Addendum No. 02

Issued: 9/13/2024

Project Name: Jordan Learning Center
Project No.: 2024528.00
Bid Package: 1

SHEET NUMBER
AS101

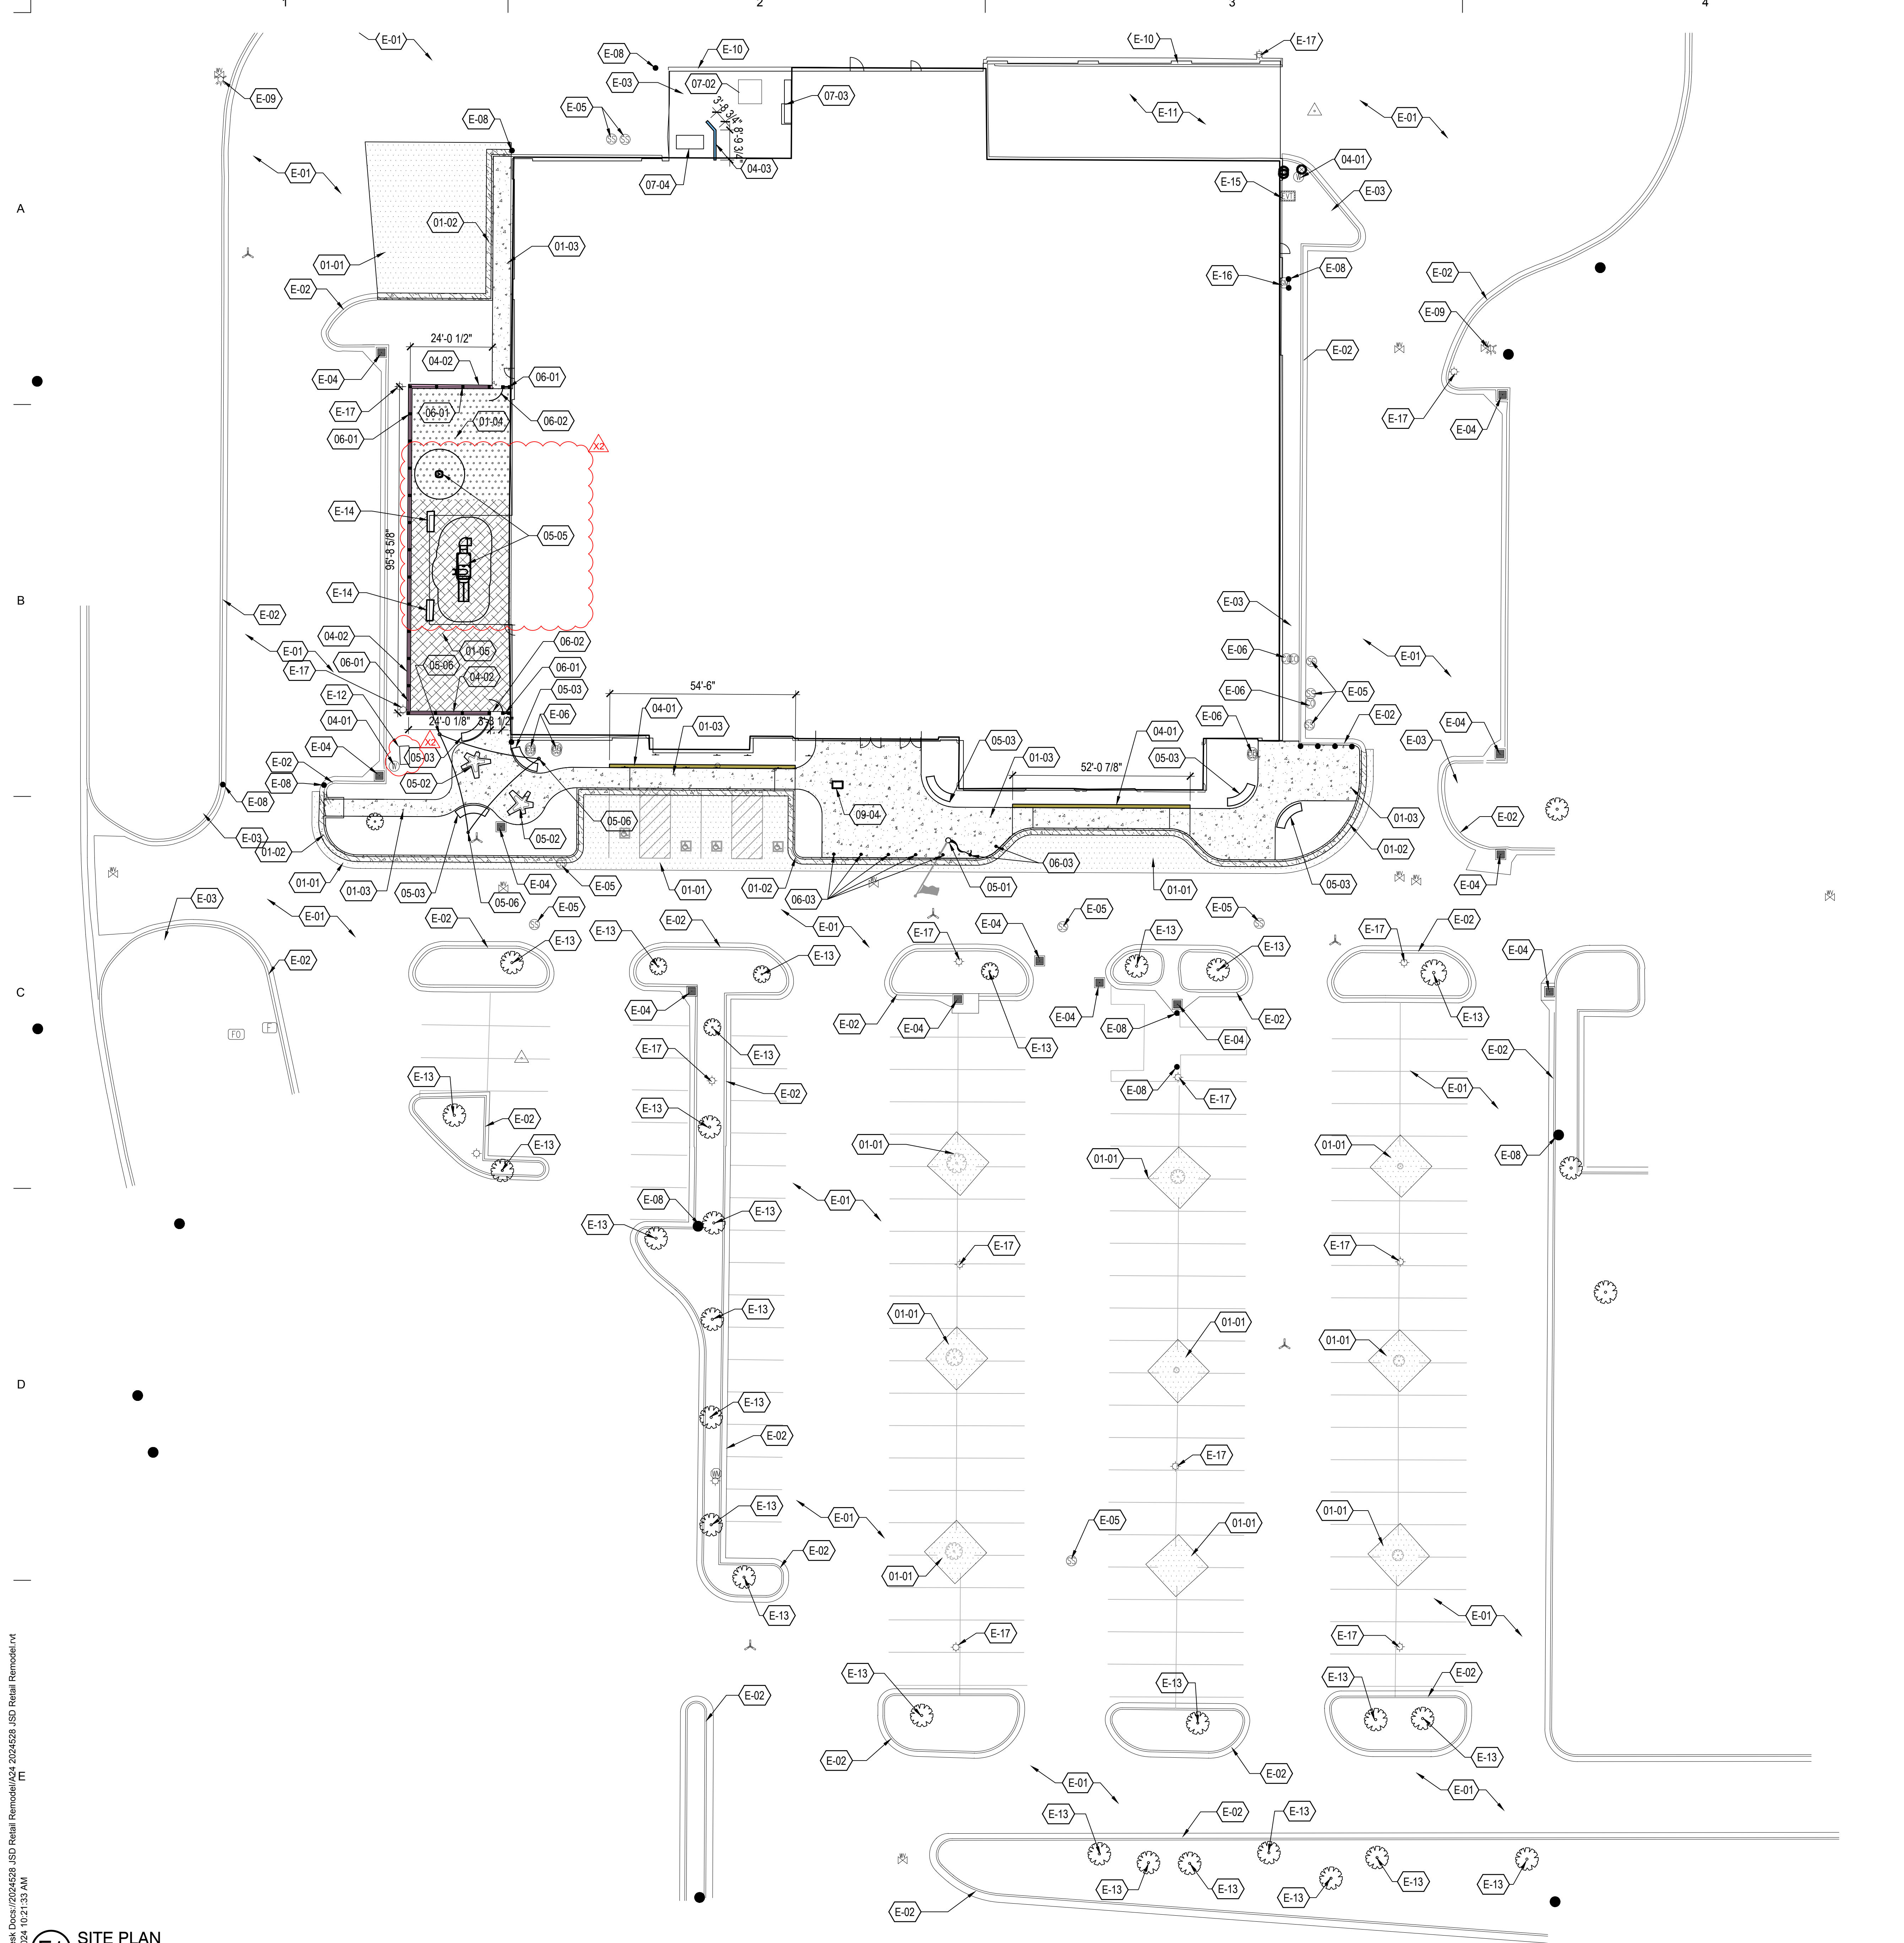
- Updated playground equipment from manufacturer.
- Updated specification numbers for synthetic grass surfacing and playground protective surfacing.
- Added specification numbers for playground equipment, fabric shade structure, and site furnishings.
- Added linework to show reference note E12- irrigation backflow preventer to be protected.
- Revised detail, related details, and specification columns on reference note schedule.

SHEET NUMBER
LI101

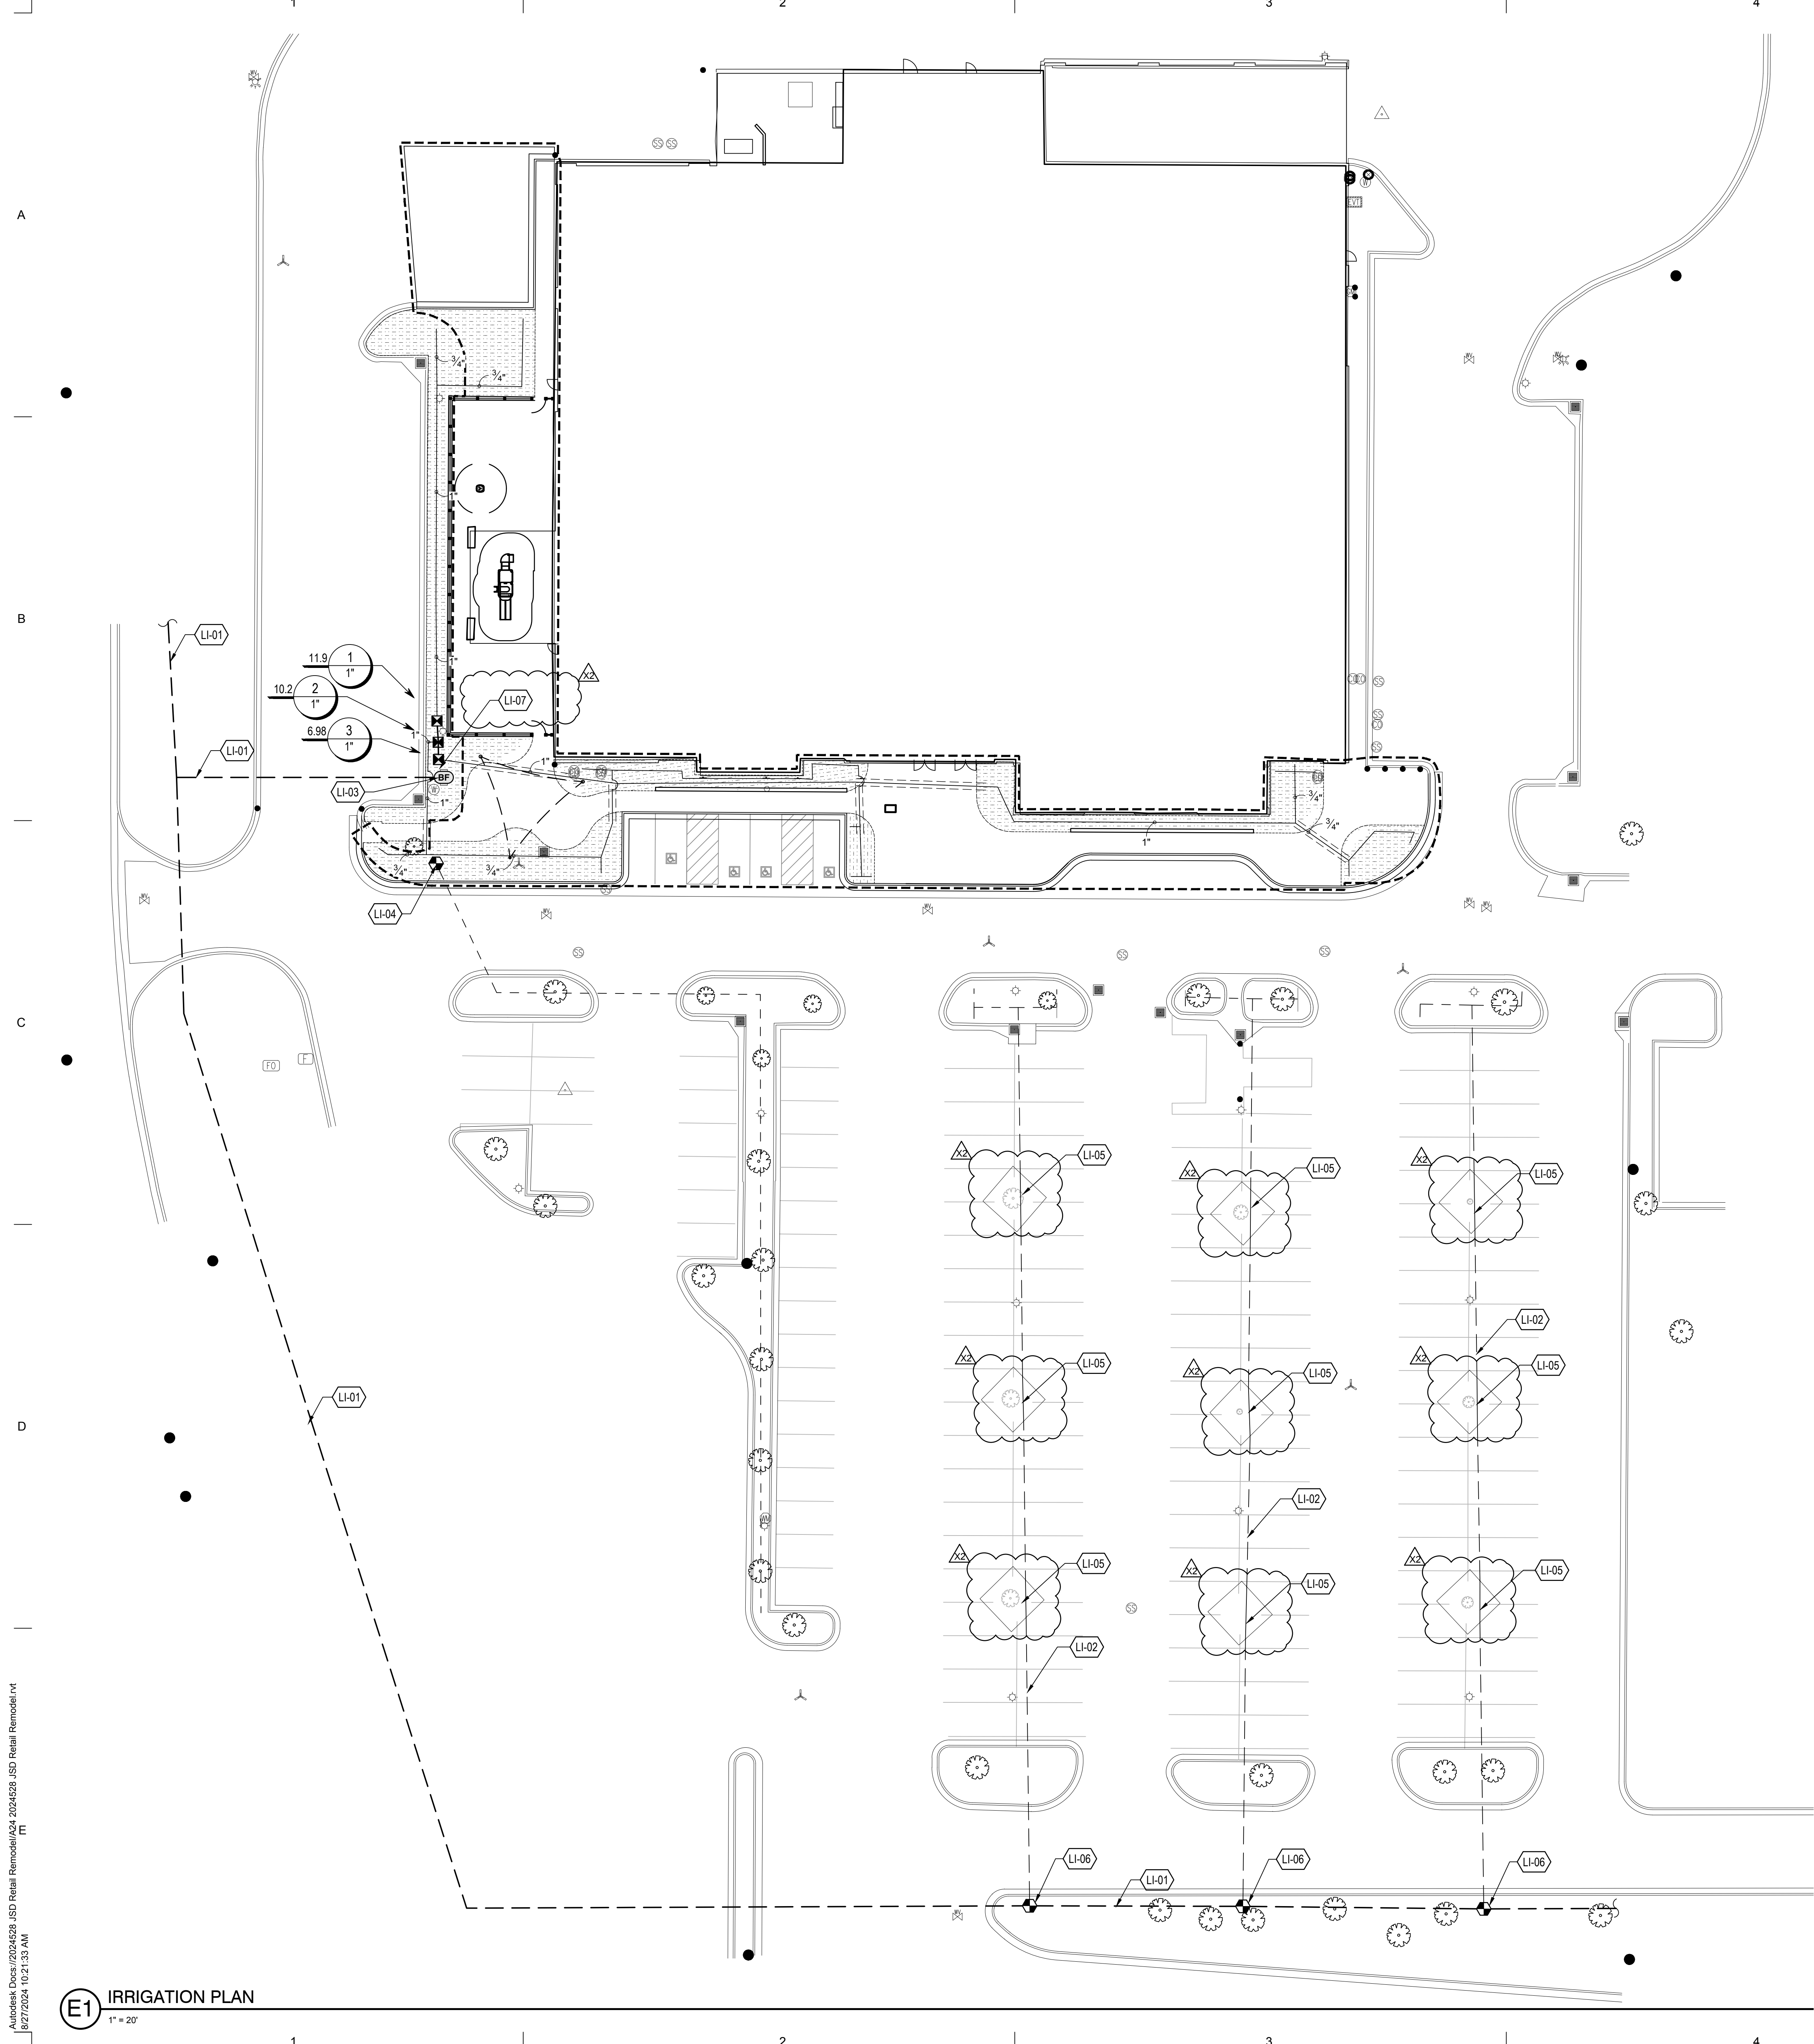
- Keynote LI-07 added.
- Lateral lines added into existing parking lot islands.

SHEET NUMBER
LP101

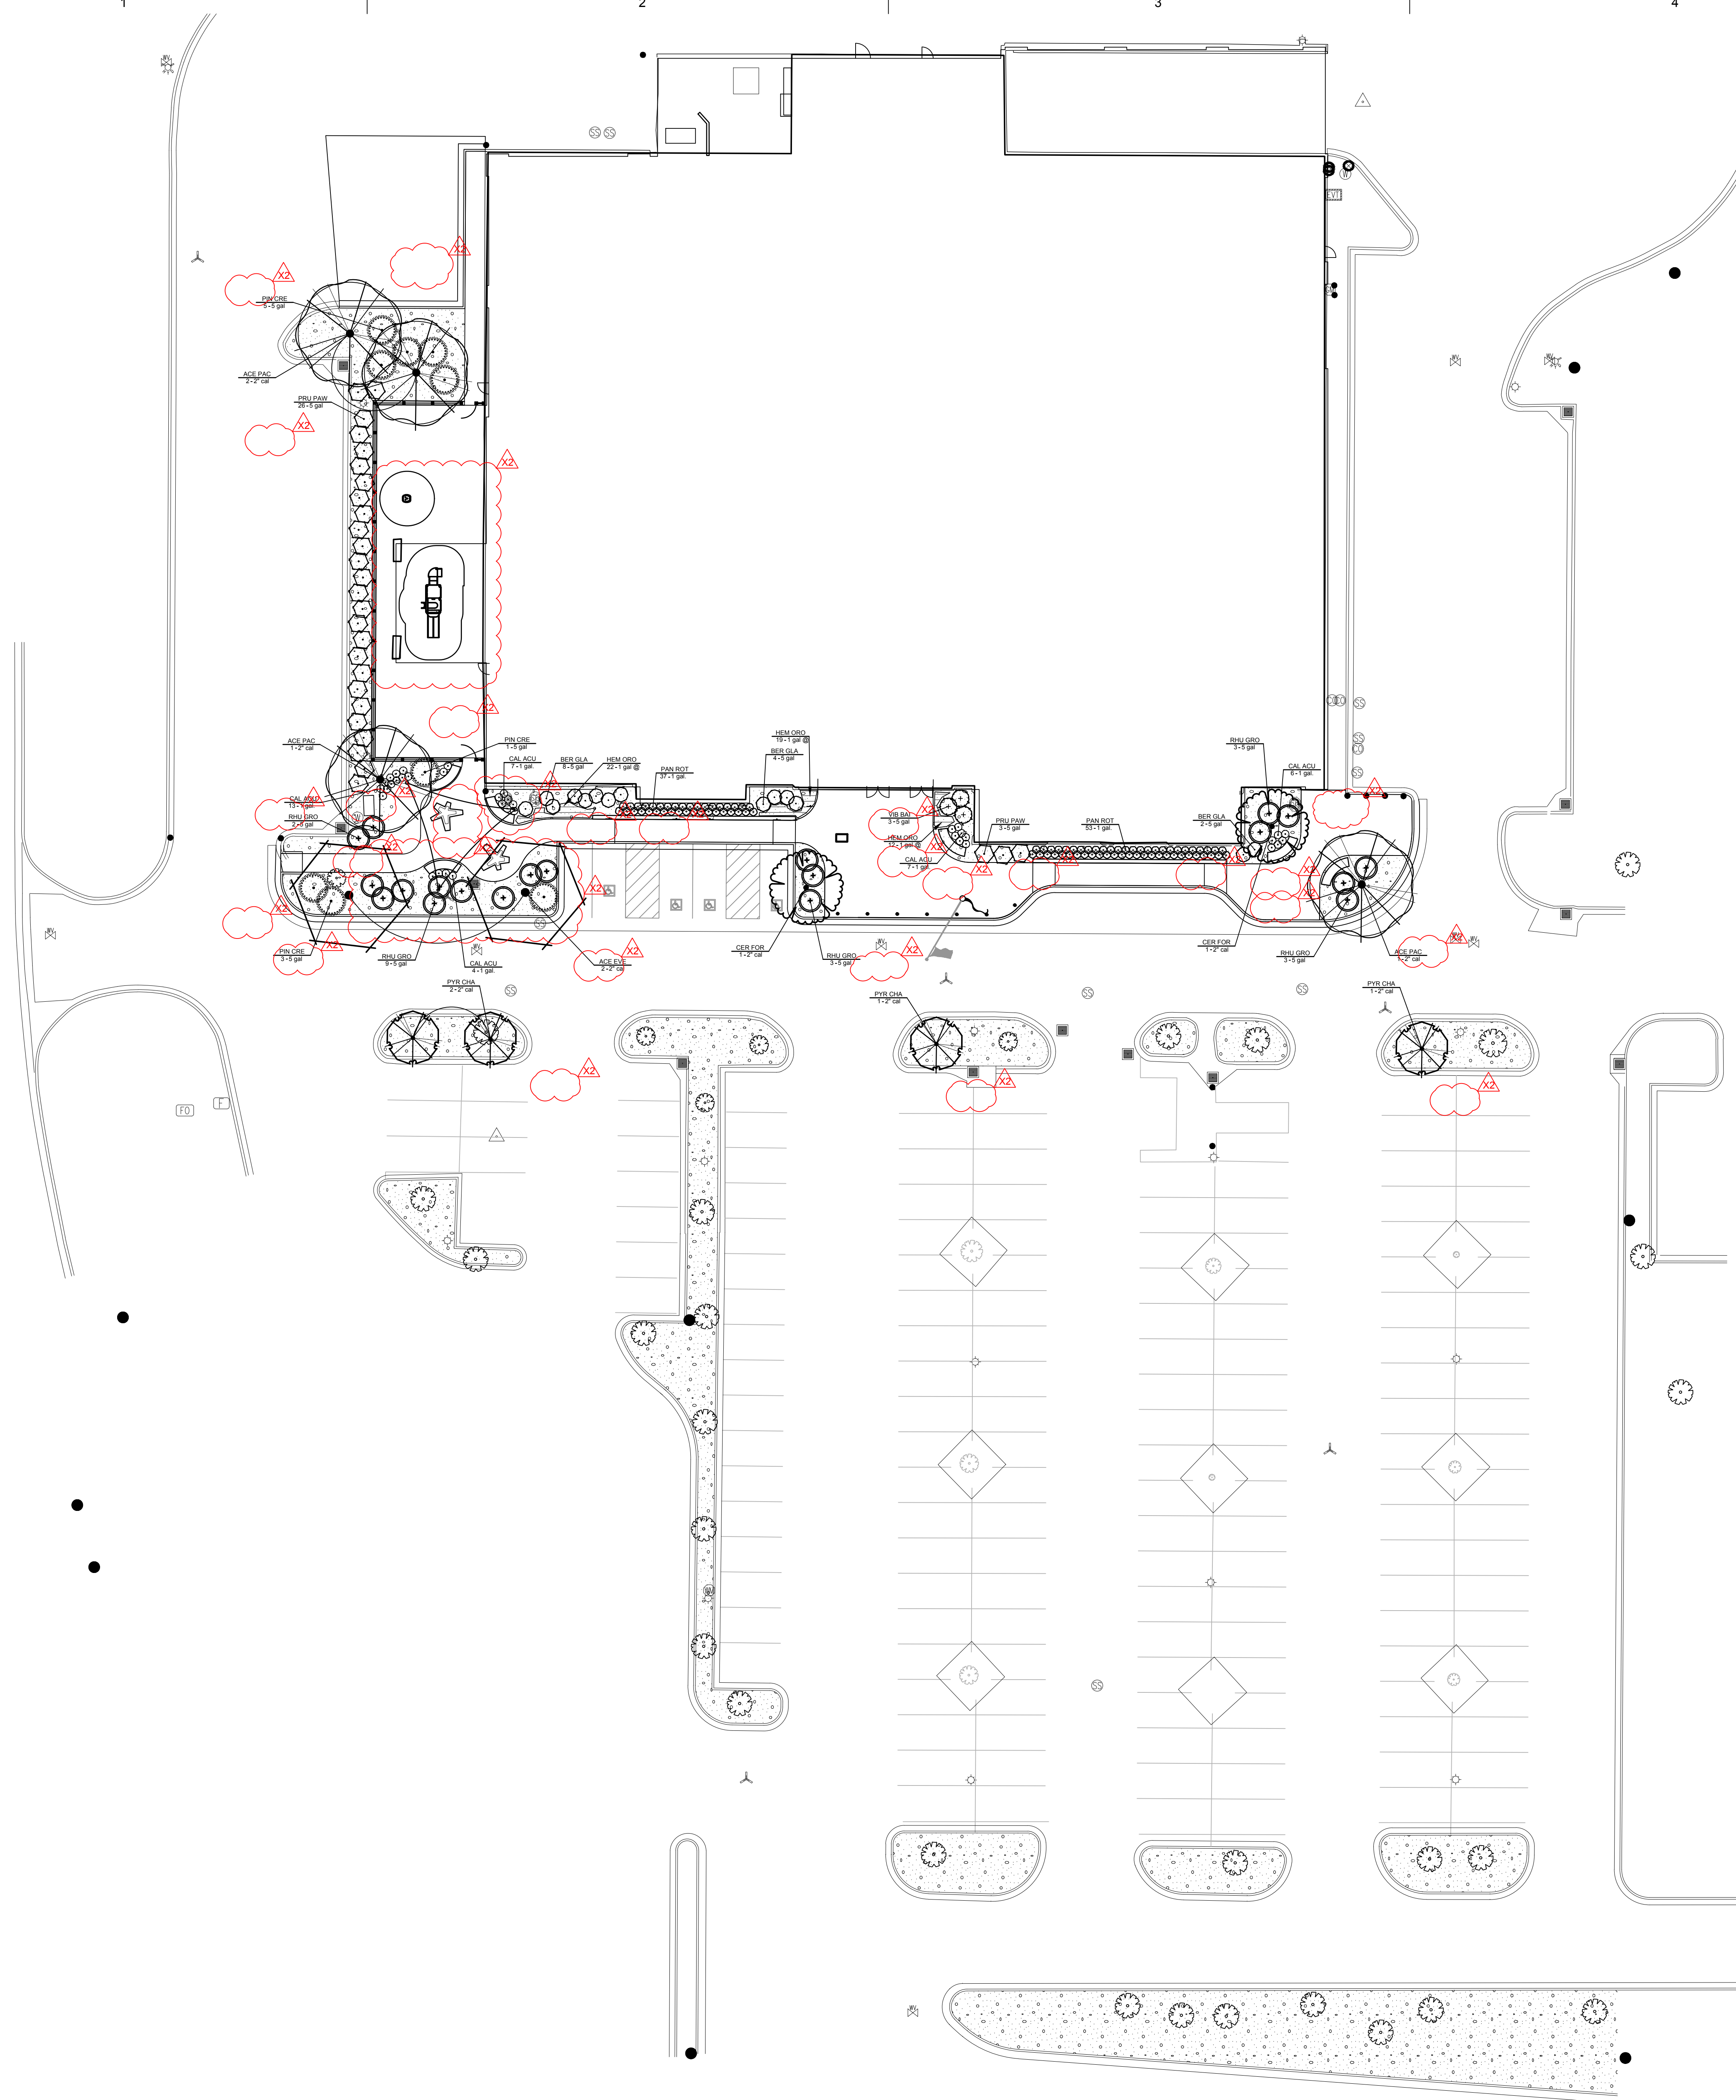
- Updated linework to show back flow in SW corner of landscape area.
- Updated planting in SW landscape area to go around shade structure poles.
- Added plant labels.
- Updated reference note schedule to include stone mulch over weed barrier fabric.
- Revised plant schedule to replace crataegus laevigata with cornus florida.
- Revised plant schedule to include correct size requirements for catalpa speciosa and crataegus laevigata.
